RE: Site Plan Application for Portland IMT, Existing Laydown and Connecting Corridor Connection
Site Plan Addendum #5

COMMENTS FROM RICK KNOWLAND, SENIOR PLANNER (VIA PLANNING BOARD REPORT, JUNE 20, 2014) AND RESPONSES:

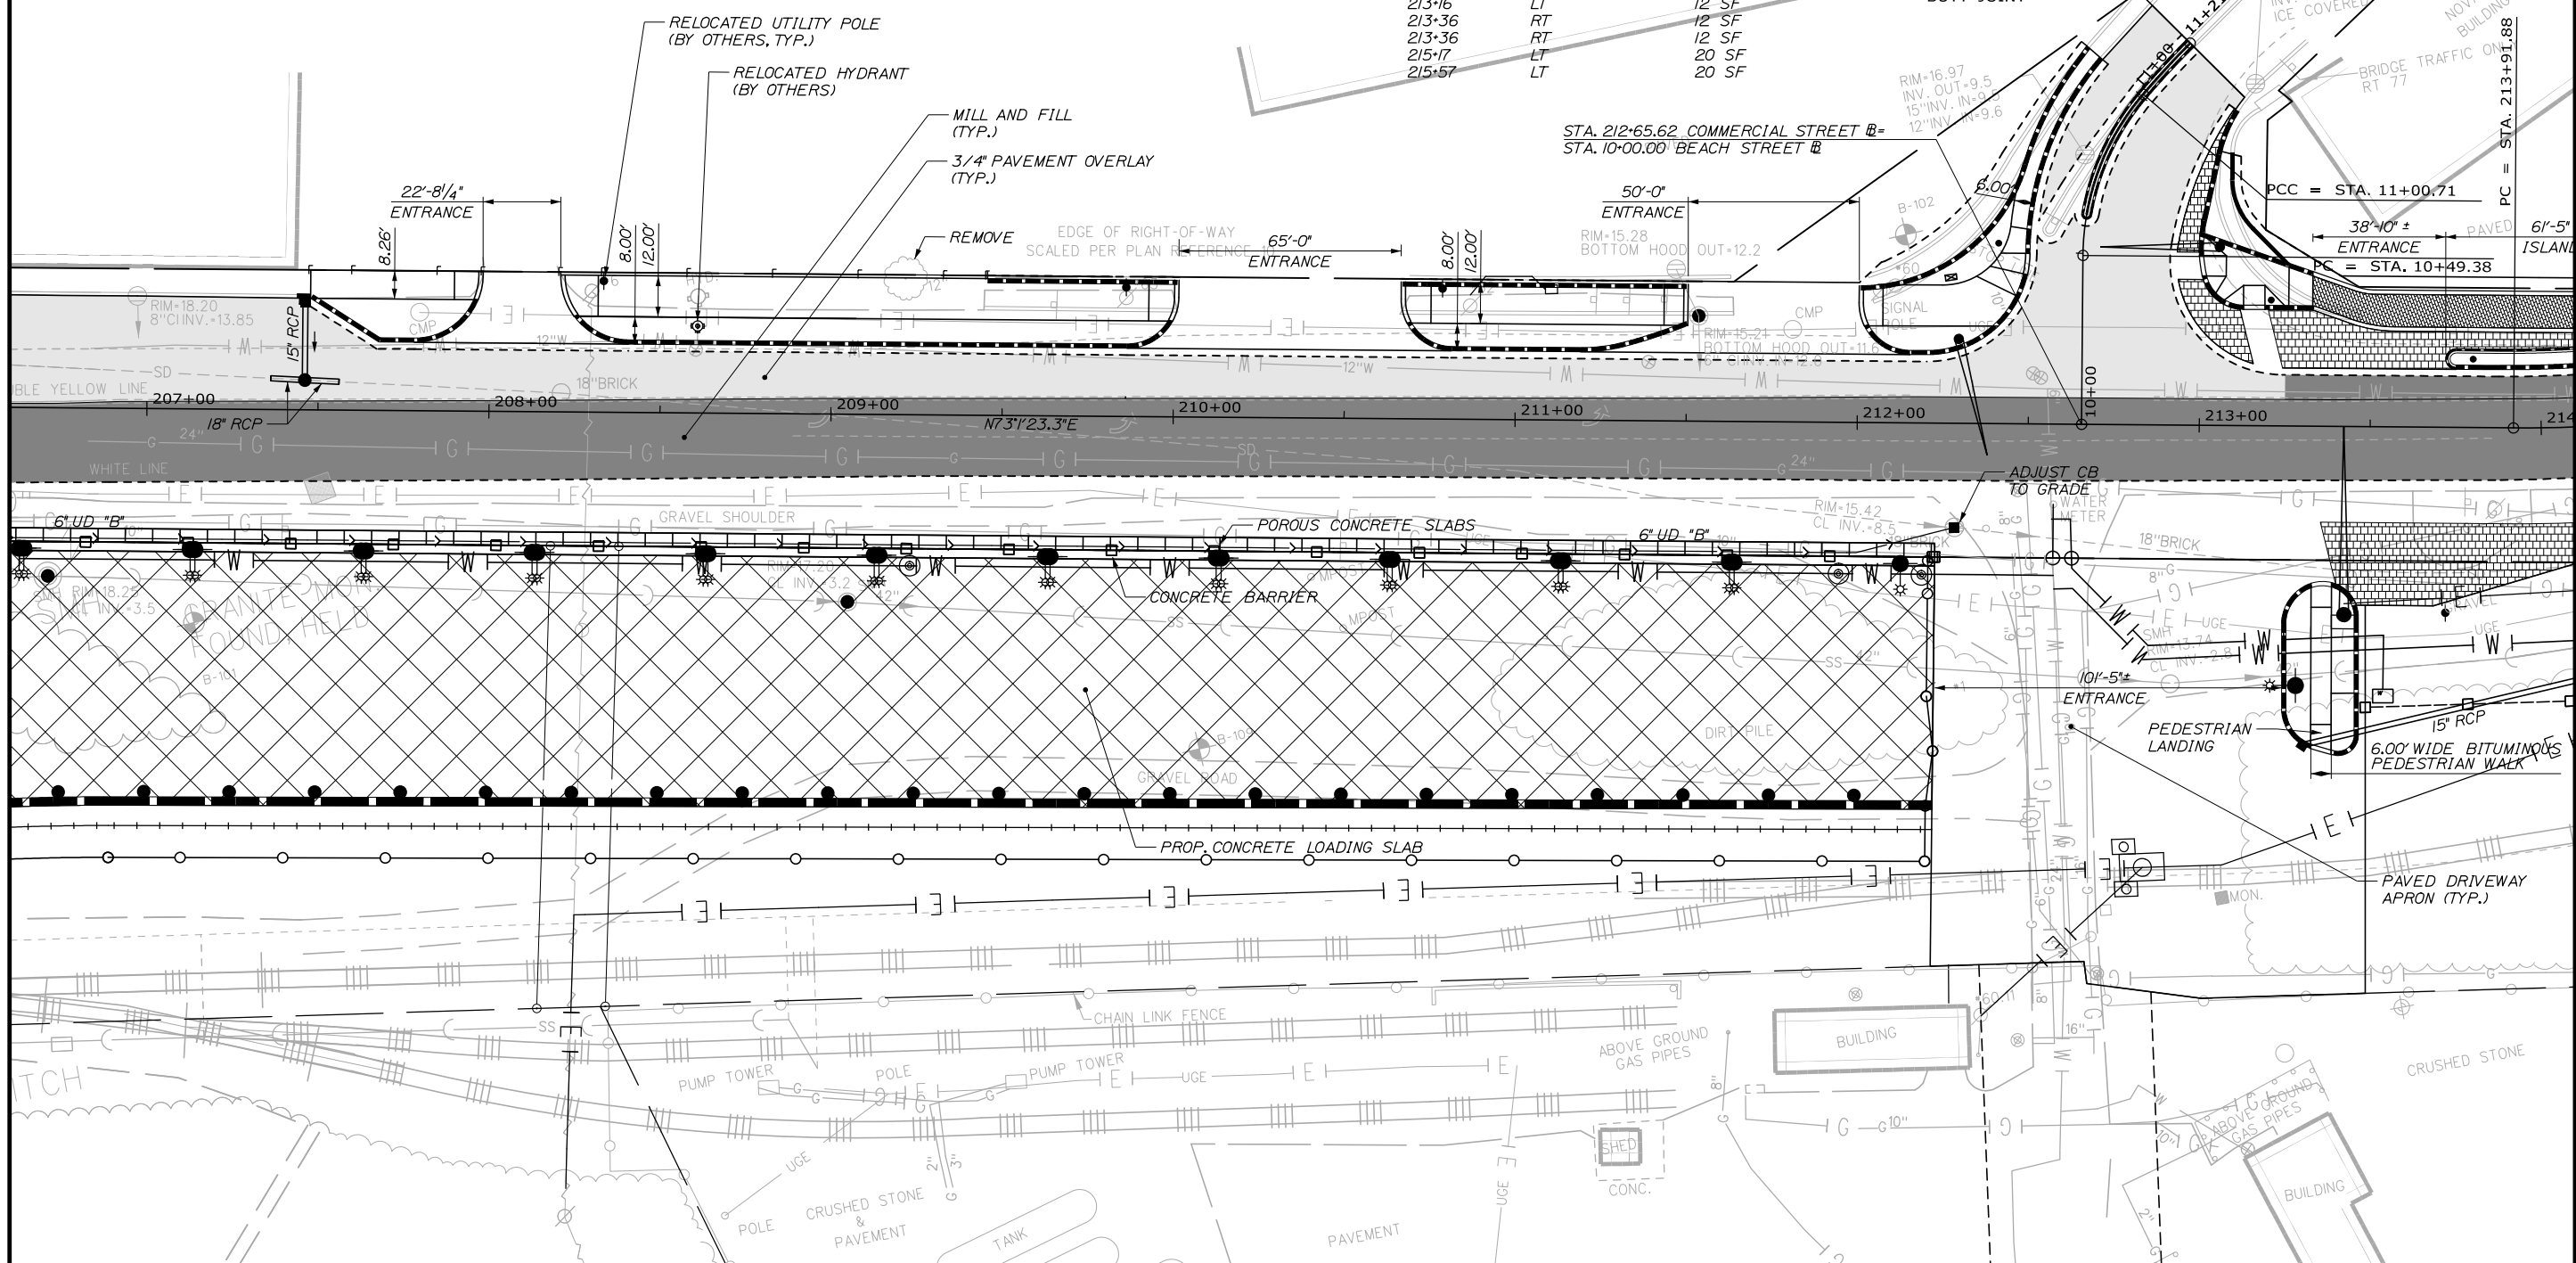
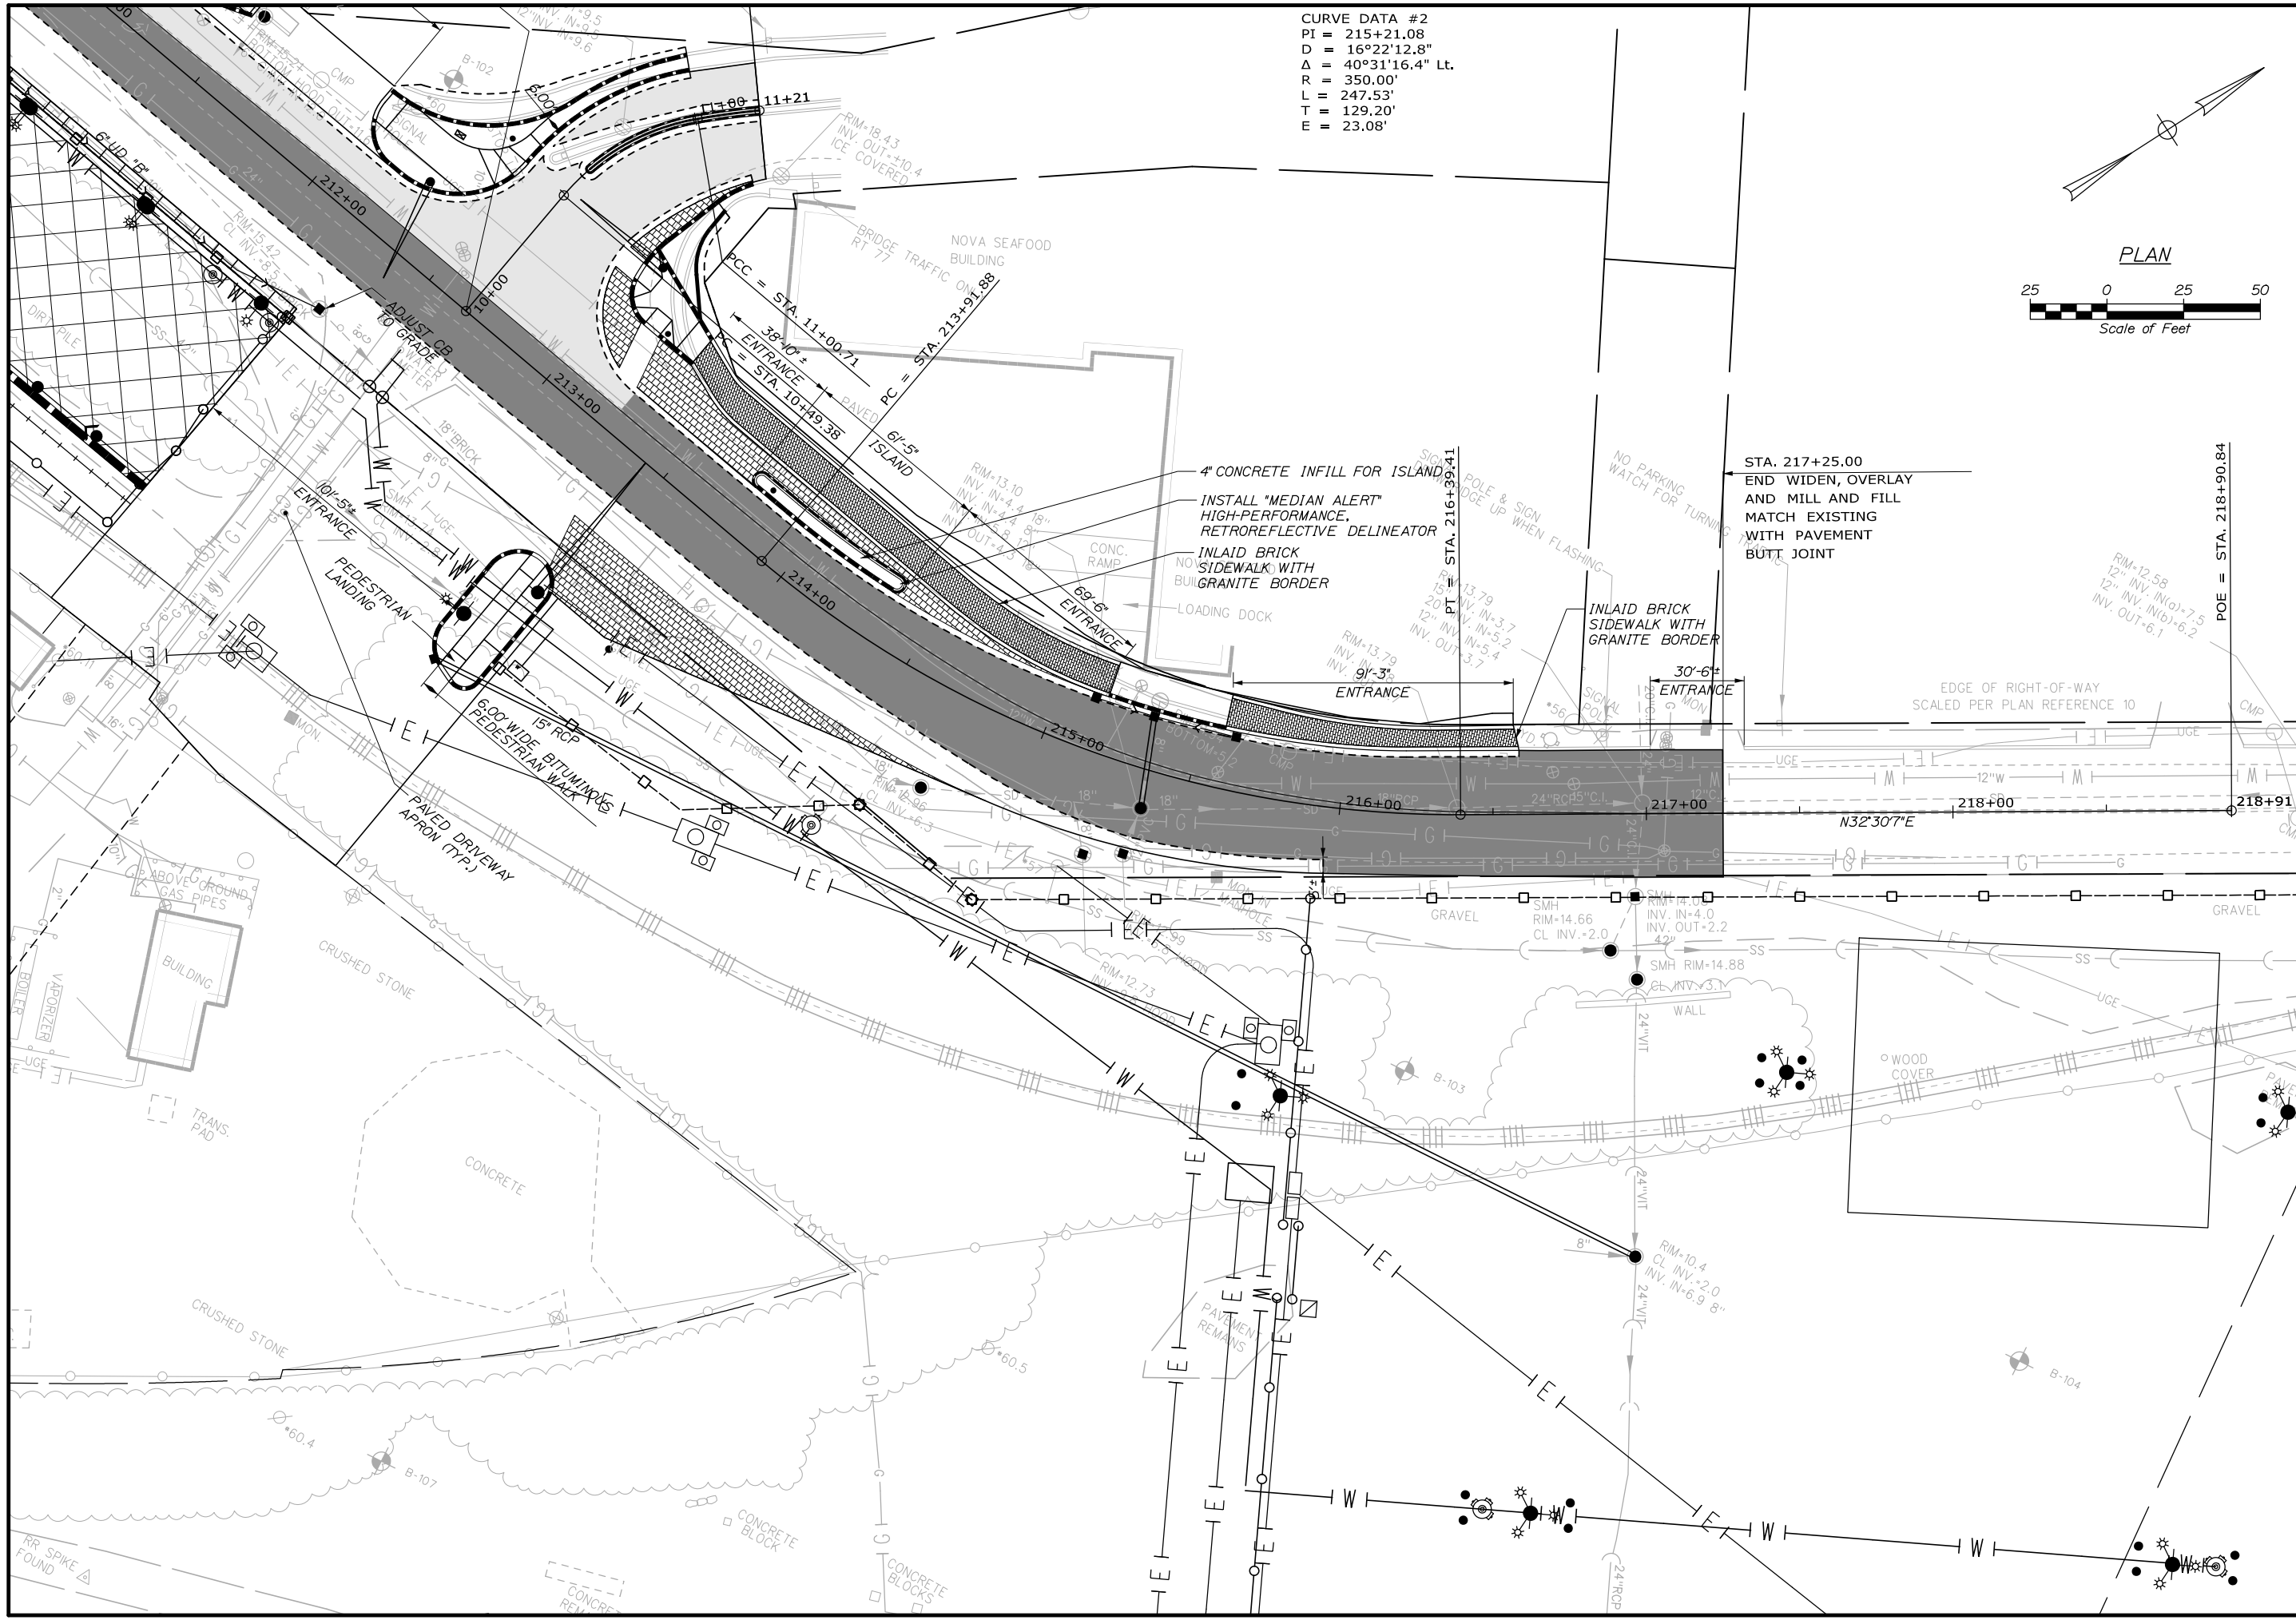
Section E. Coordination with Adjacent Development Parcels: In reviewing the IMT site plan, staff finds that the application has not met all of the site plan submission requirements of sec. 14-527(d), in particular, the following items of this section.

- (4) Location, dimensions and materials of all existing and proposed driveways, vehicle and pedestrian access ways.
- (22) Location, sizing, and directional flows of all existing and proposed utilities within the project site and on all abutting streets.
- (31) Location, dimensions and ownership of easements public or private rights of way, both existing and proposed.

- *Commercial Street Plans H05 and H06 have been revised to show driveway, vehicle and pedestrian access way information.*
- *Site Plans C06, C07, and C08 have been revised to show required easement information.*
- *Site Grading and Drainage Plan C09 has been revised to include location, sizing, and directional flows of utilities.*

SHEET NUMBER
C09
12 OF 113

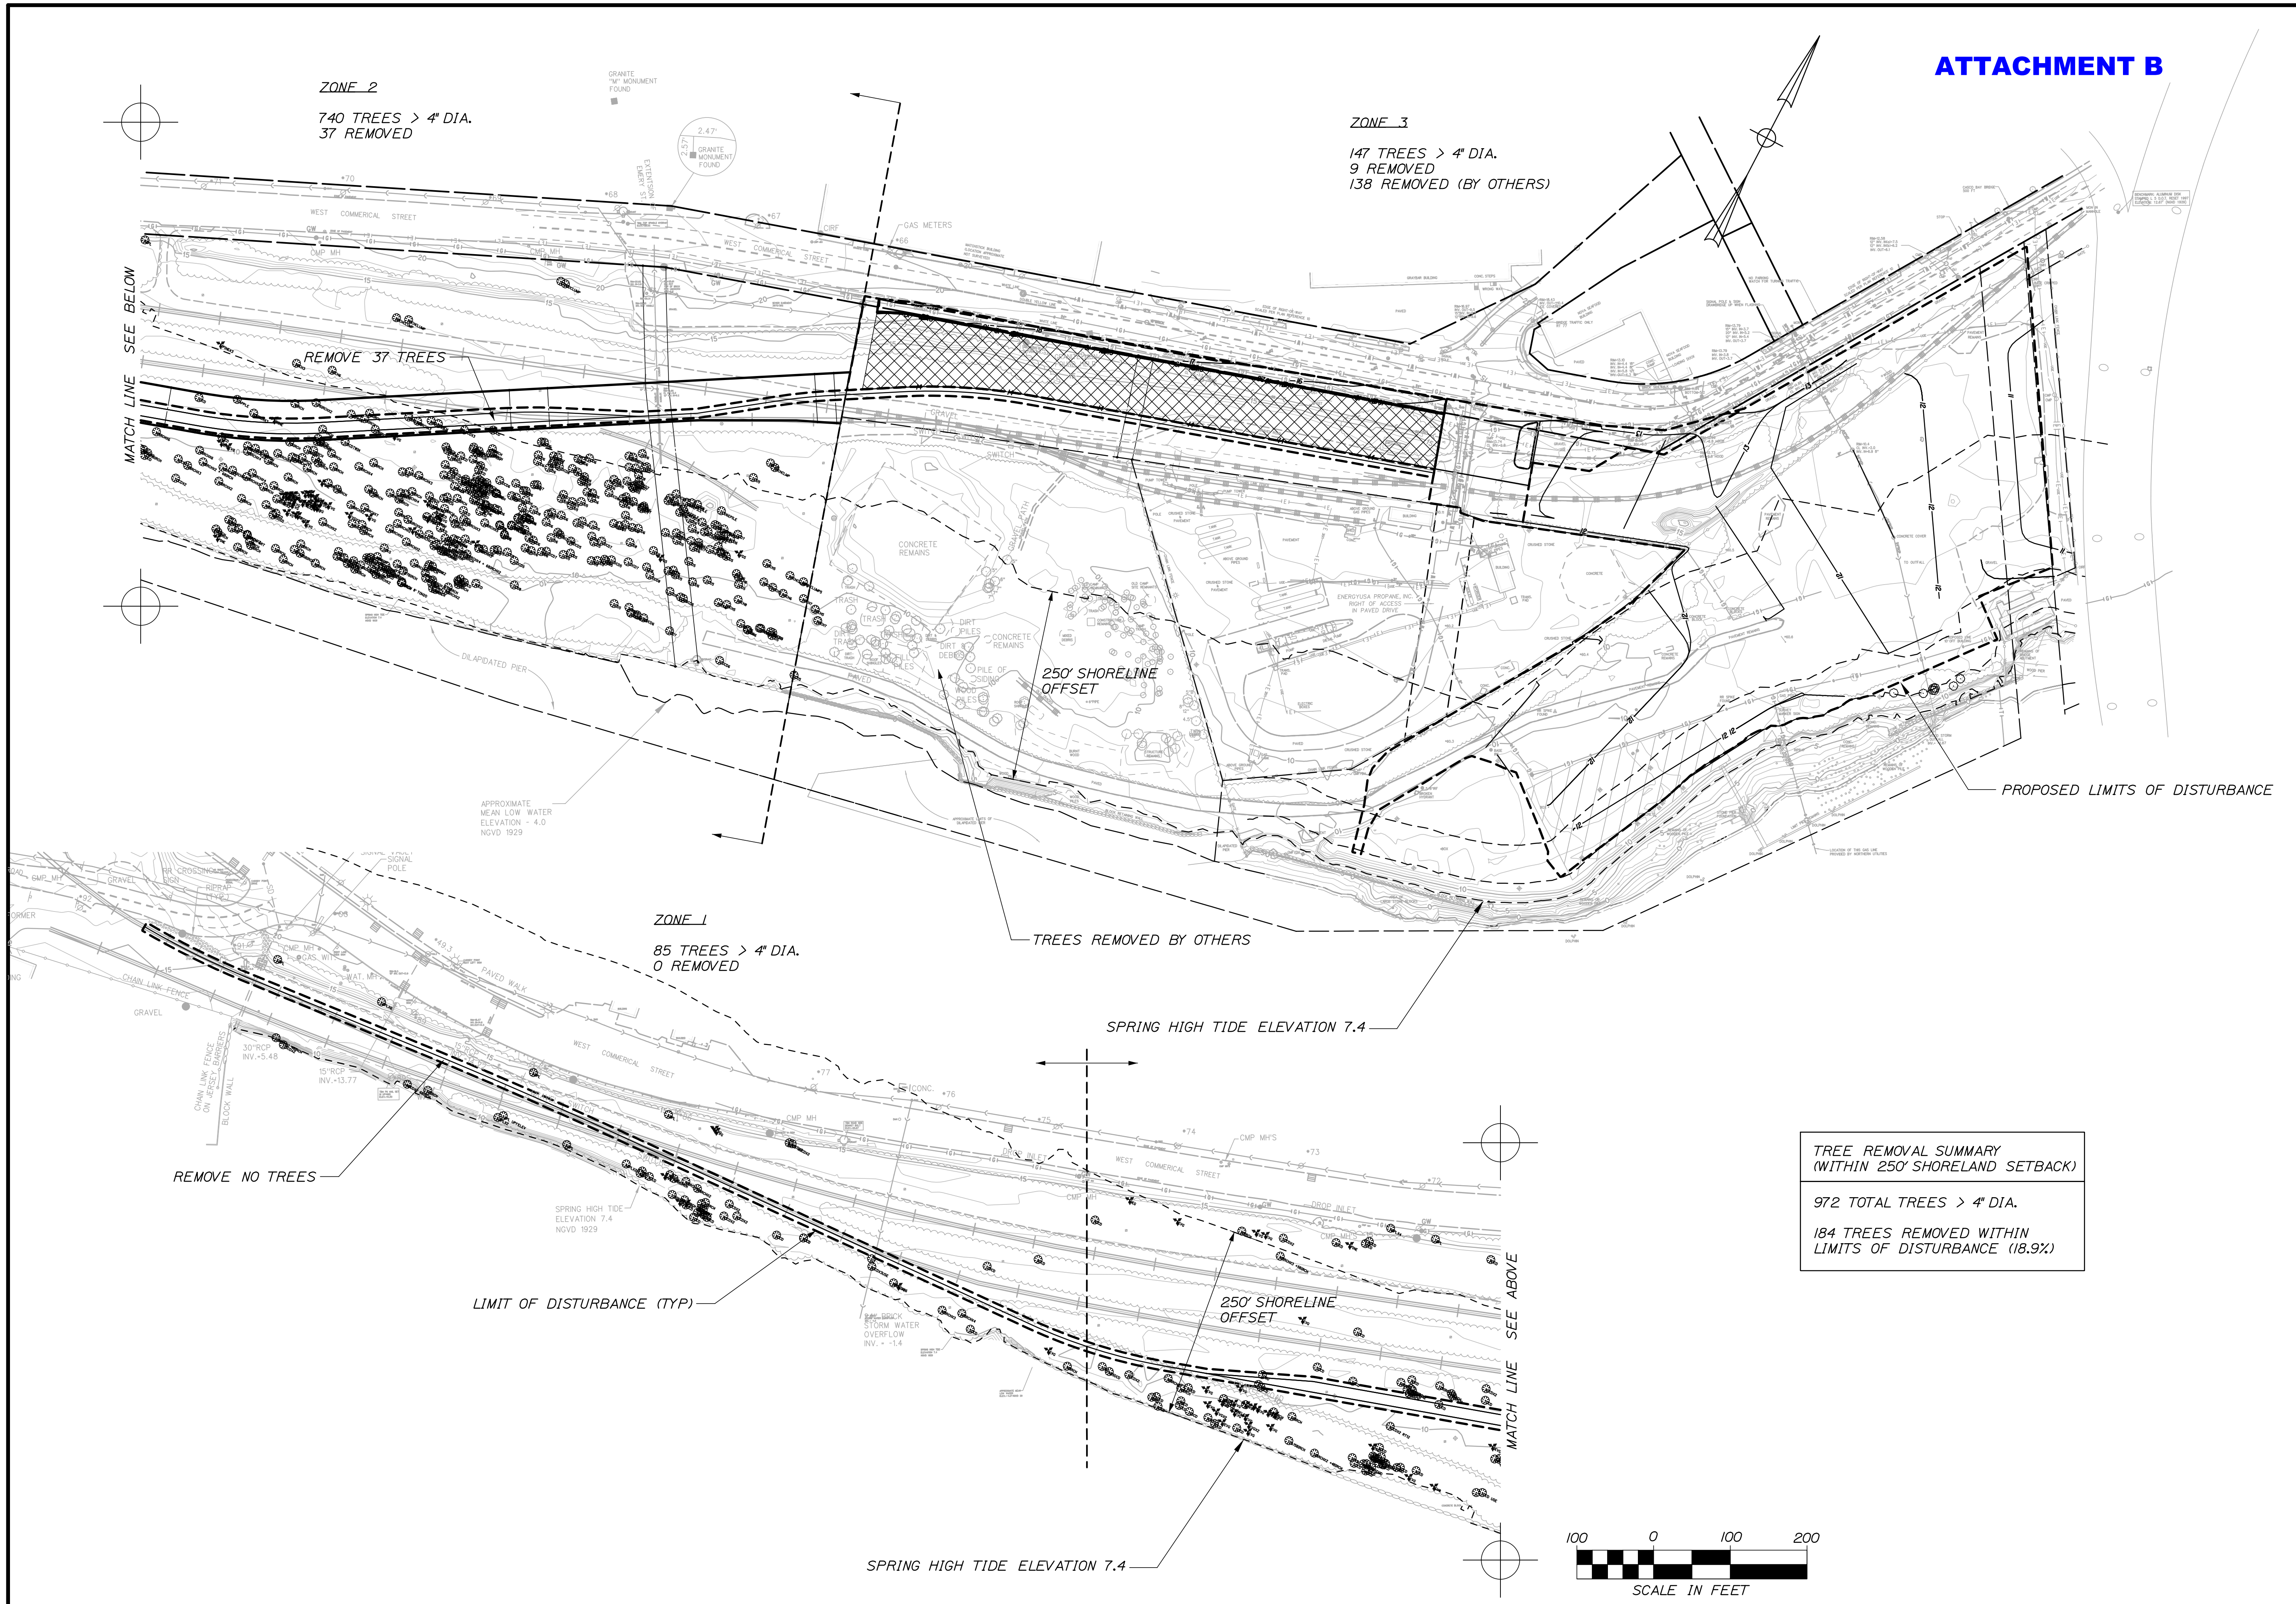
The plan should clarify where new gravel will be installed on the site including a cross section of the depth and type of material.

Response: Site Grading and Drainage Plan C09 shows the limits for the new granular improvements in the Chassis Storage Yard and Site Details C13 shows the typical section which will be used for this area (see Attachments A and E).
